**RE: Town of Kittery, Planning Board Services
35 Badgers Island West Residential Conversion Drainage Review #3
Tax Map 1, Lot 32
CMA #591.156**

**Re: Preliminary Site Plan Review Application; Conversion to Residential
Tax Map 1, Lot 32, 35 Badgers Island West
Response to CMA Comments**

UTILITY PLAN **C3**

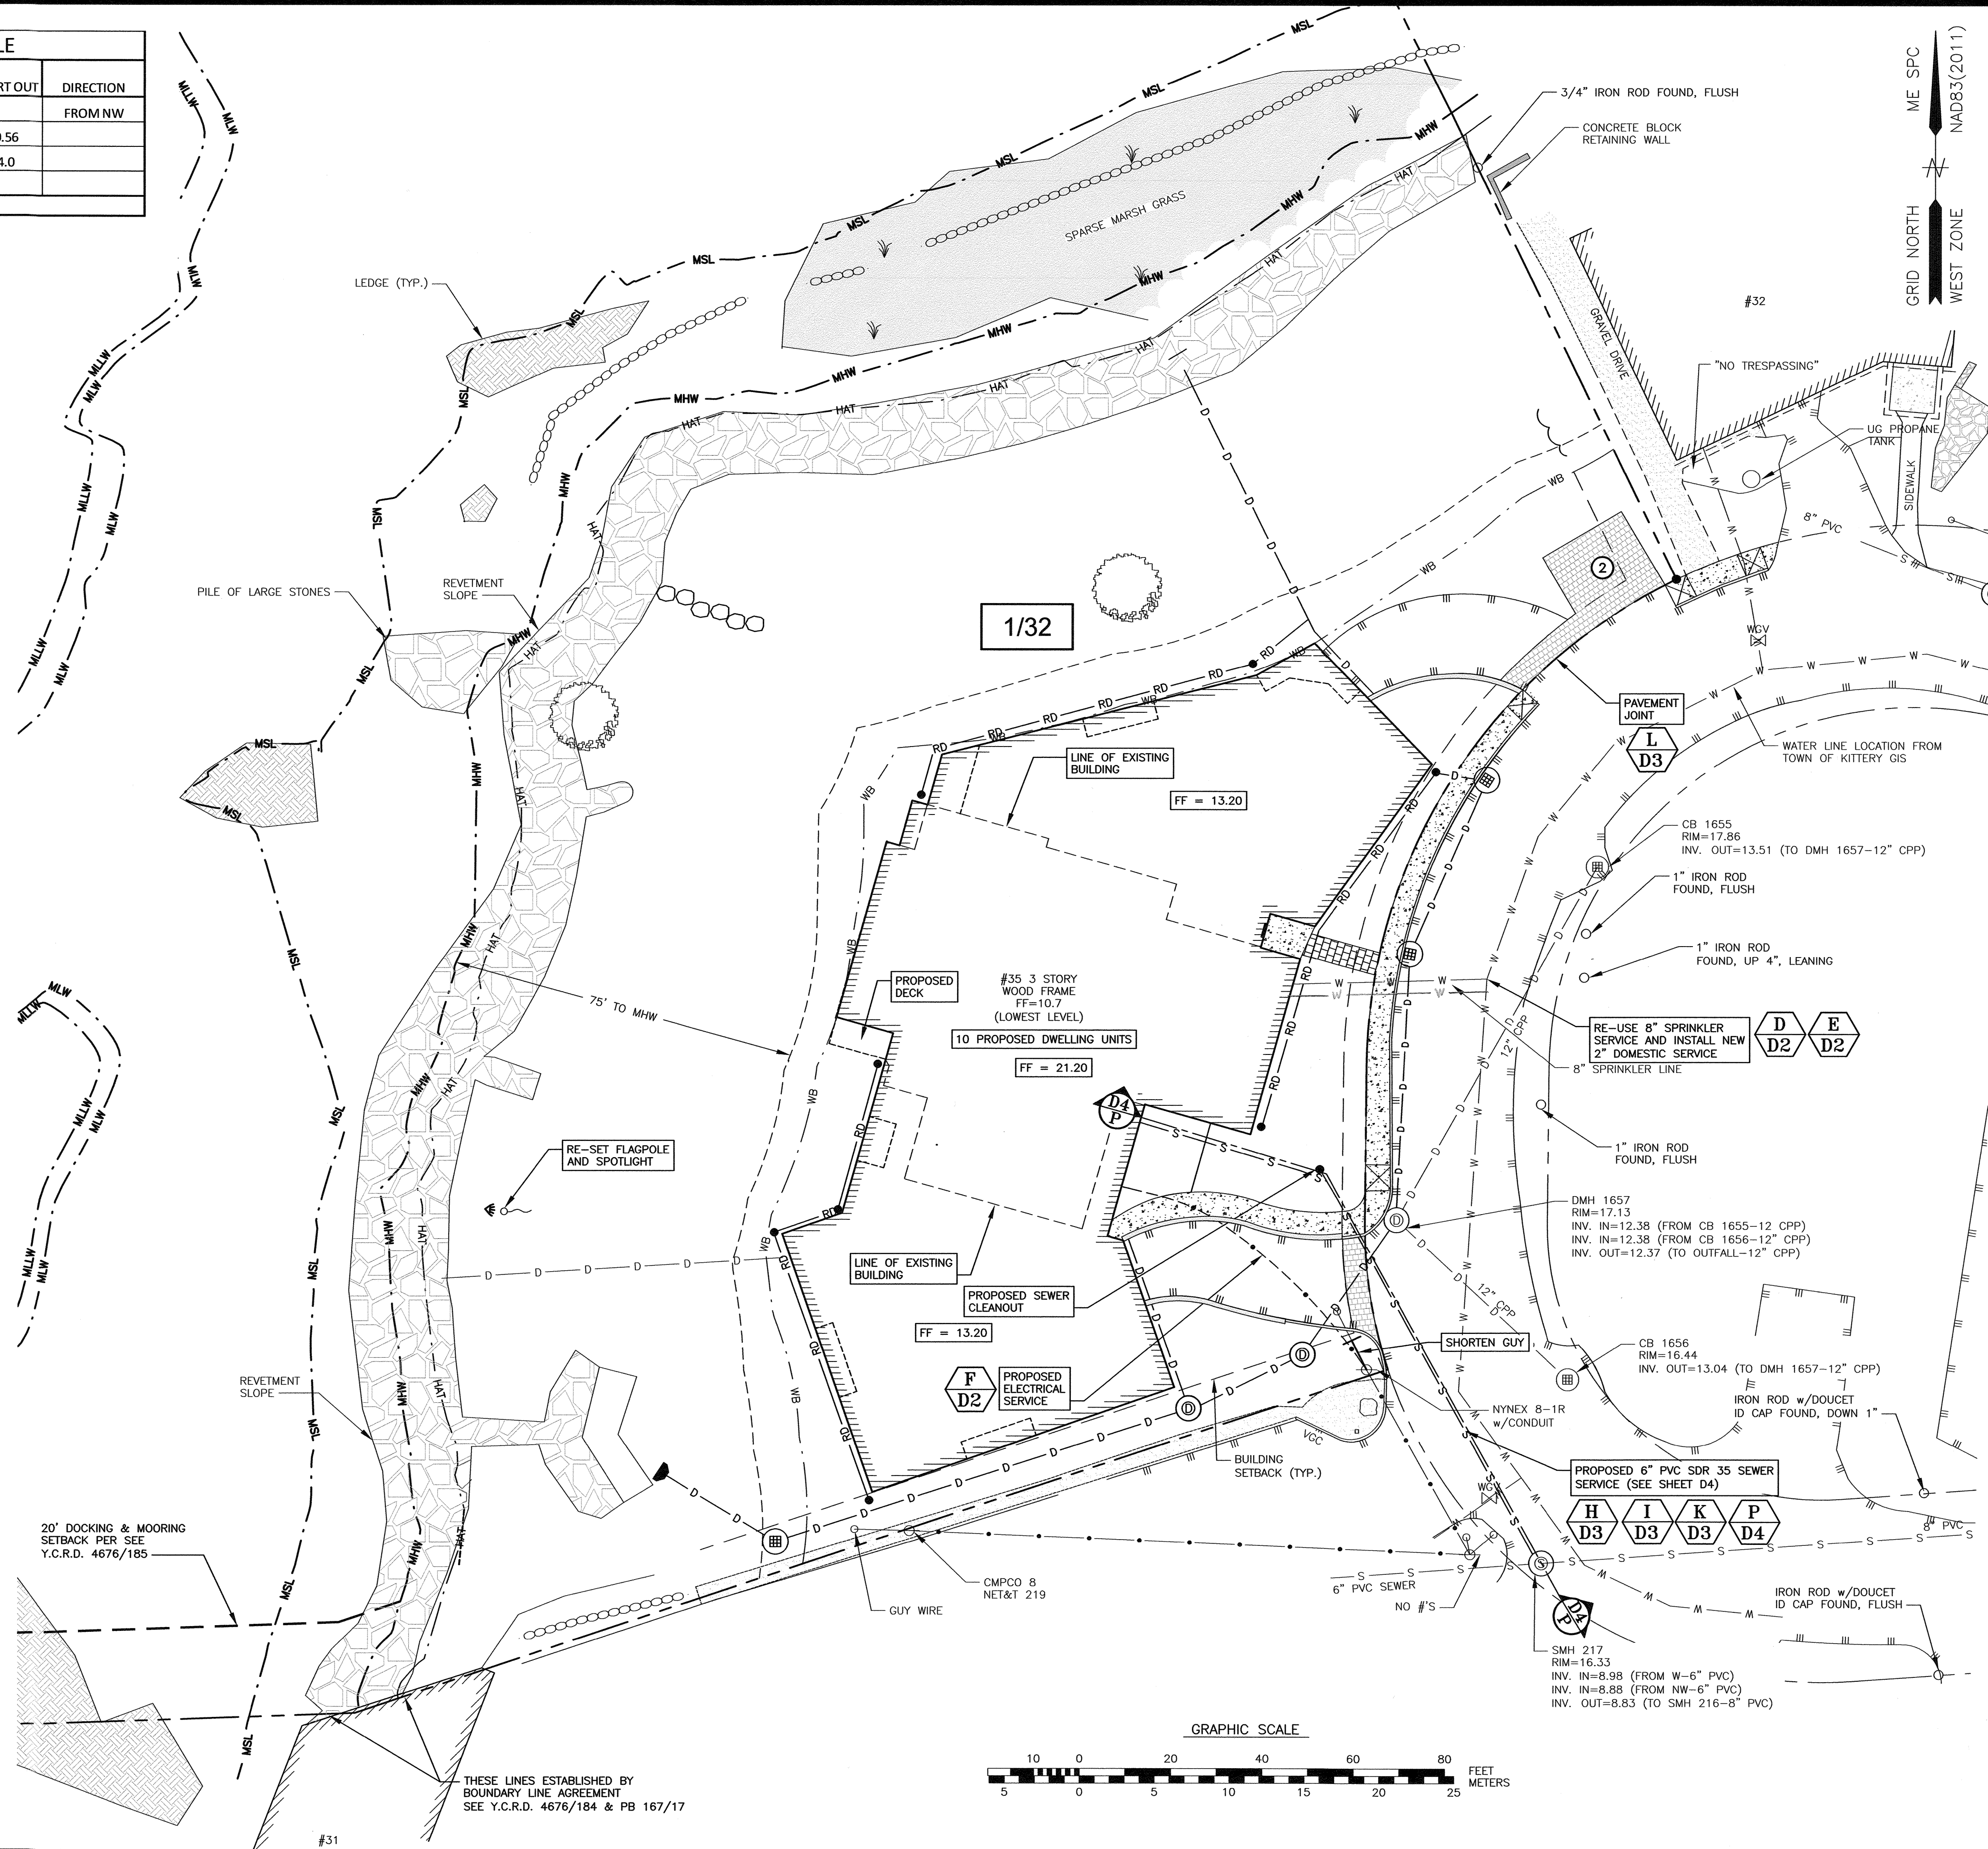
Sheet C3 – Utility Plan

1. The proposed sewer service contains a change in pipe direction at a three-foot drop in elevation and is serviced by a cleanout. This is not a conventional design and has the potential to easily become clogged. The design should include a manhole with a drop inlet.
2. The invert of the pipe at the cleanouts is labeled as 14.0' but 13.56' in the Sewer Plan and Profile on Sheet D4.

1. The proposed sewer service contains a change in pipe direction at a three-foot drop in elevation and is serviced by a cleanout. This is not a conventional design and has the

potential to easily become clogged. The design should include a manhole with a drop inlet. **Please see attached a PVC manhole to address the concern. Once approved we will update the plans.**

2. The invert of the pipe at the cleanouts is labeled as 14.0' but 13.56' in the Sewer Plan and Profile on Sheet D4. **Those numbers are correct. The 14.0 is the invert out at the building, consistent on both sheets.**

GRADING PLAN **C4**

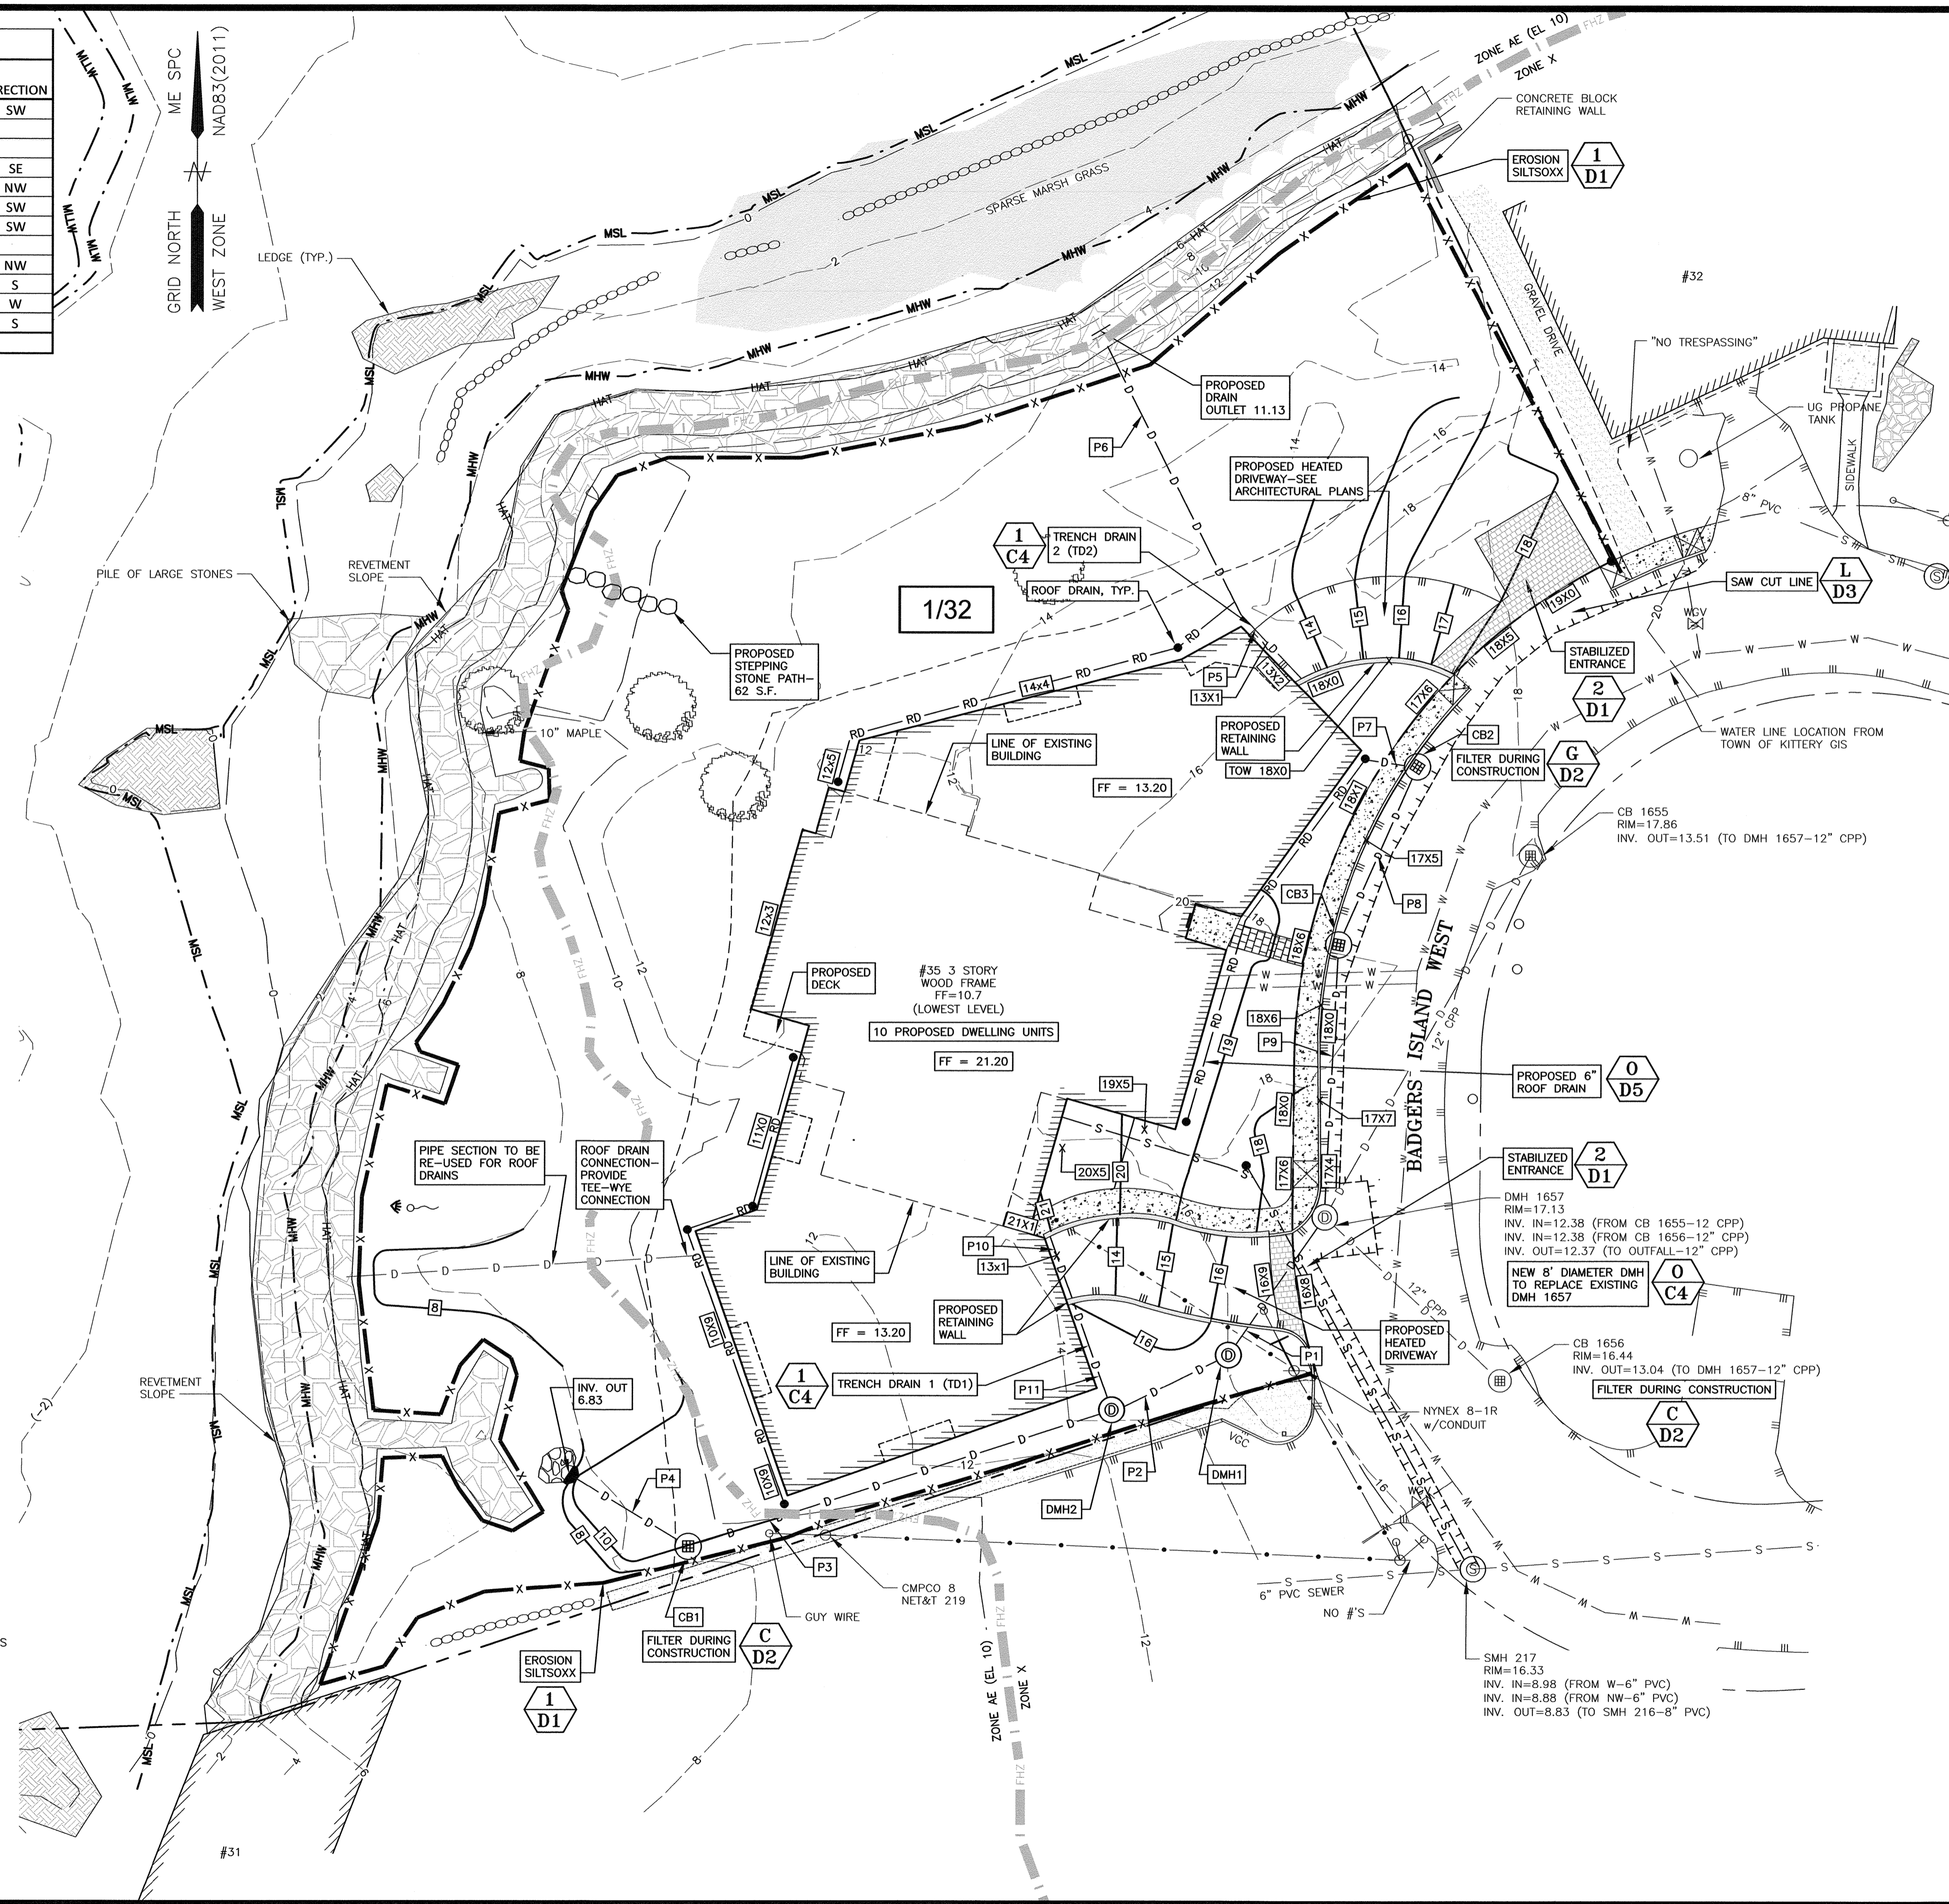
Sheet C4 – Grading Plan

1. The applicant is now proposing to replace DMH #1657, which is located in the Town right-of-way. Is this acceptable to the department of public works? What are the details of the pipe connections?
2. Amend the leader "Pipe to be terminated at DMH 1657..." The manhole is being replaced. The pipe should be removed or filled in and capped to the roof leader tie-in point.
3. The new 18" pipe at DMH 1657 is called out as 18" CPP on the drainage structure table. Is this correct or should it be HDPE? Is the existing 12" pipe in HDPE or CPP?

1. The applicant is now proposing to replace DMH #1657, which is located in the Town right-of-way. Is this acceptable to the department of public works? What are the details of the pipe connections? **The reviewer previously commented.... “Has the condition of the existing structures (namely DMH 1657) been assessed? What size is DMH 1657? Is there room in the structure for two additional pipe penetrations?” This was a good comment as the review indicated that the DMH needed to be replaced.**

2. Amend the leader “Pipe to be terminated at DMH 1657...” The manhole is being replaced. The pipe should be removed or filled in and capped to the roof leader tie-in point. **Done, the pipe will be removed.**

3. The new 18” pipe at DMH 1657 is called out as 18” CPP on the drainage structure table. Is this correct or should it be HDPE? Is the existing 12” pipe in HDPE or CPP? **HDPE.**
